<b>TO:</b>	<b>Dr. Cone,</b> Superintendent of Schools, LVISD	<b>FROM:</b>	<b>Catherine Blackler</b> <i>Catherine Blackler</i> Senior Project Manager, AGCM
<b>cc:</b>	Belinda Raindl, LVISD		Michael Rogers, AGCM
<b>RE:</b>	La Vernia ISD – Bond 2023	<b>DATE:</b>	June 18, 2025
<b>SUBJECT:</b>	PR No. 08	<b>PR DATE:</b>	April 25, 2025
<b>PR COST:</b>	\$ 8,128.00	<b>CONTRACTOR:</b>	Bartlett Cocke (RCO 13R1)

Architect's Project Number: 22075  
Proposal Request Number: 08  
Proposal Request Date: April 25, 2025

**PR No.:** 08 / Delta 18  
**Date:** 04/11/2025  
**Project:** La Vernia ISD Renovations  
**Number:** 25480

UNDERFLOOR PLAN - JUNIOR HIGH - AREA A-1 - PLBG  
**P1.1M**  
PACKAGE 2

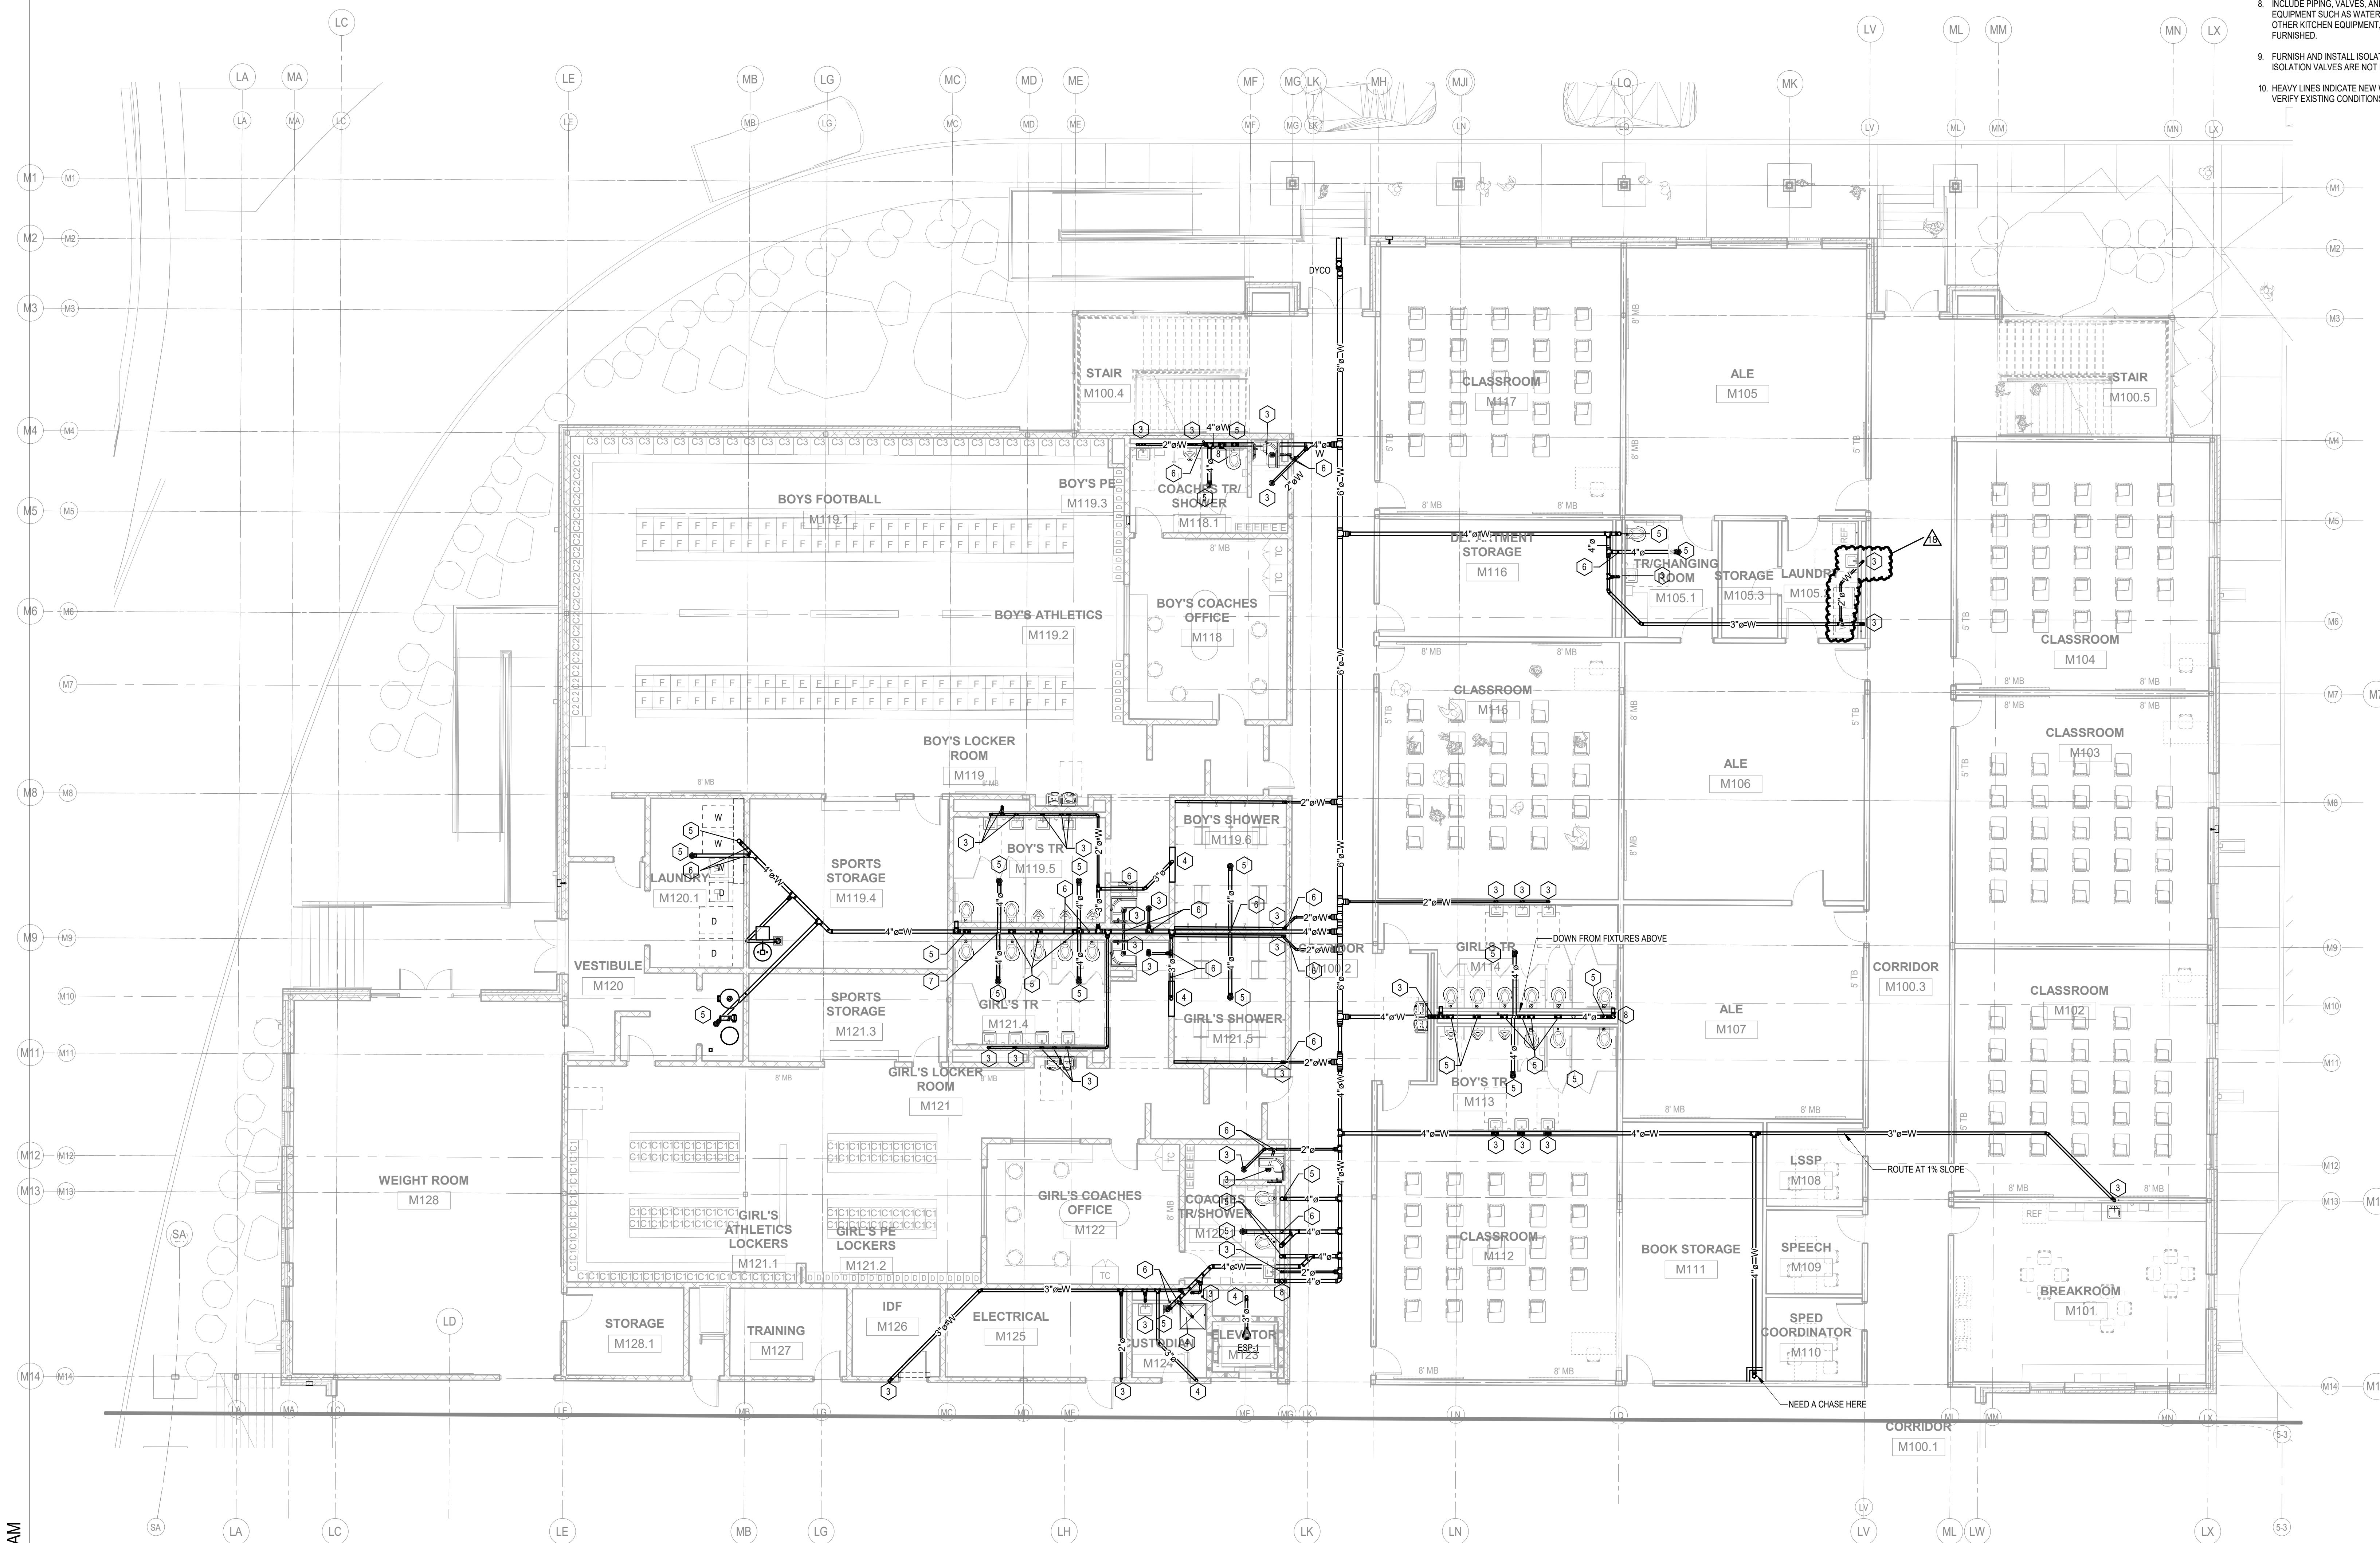
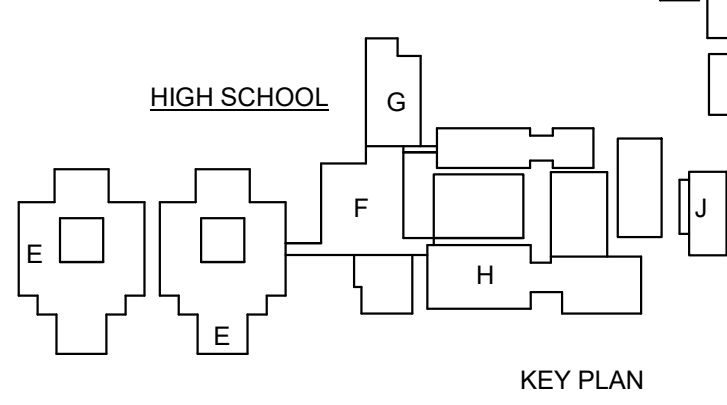
P1.1M – UNDERFLOOR PLAN – JUNIOR HIGH – AREA A-1 – PLBG

1. Add 2" waste to serve hand sink at Laundry Room M105.2 as shown on attached, revised sheet.
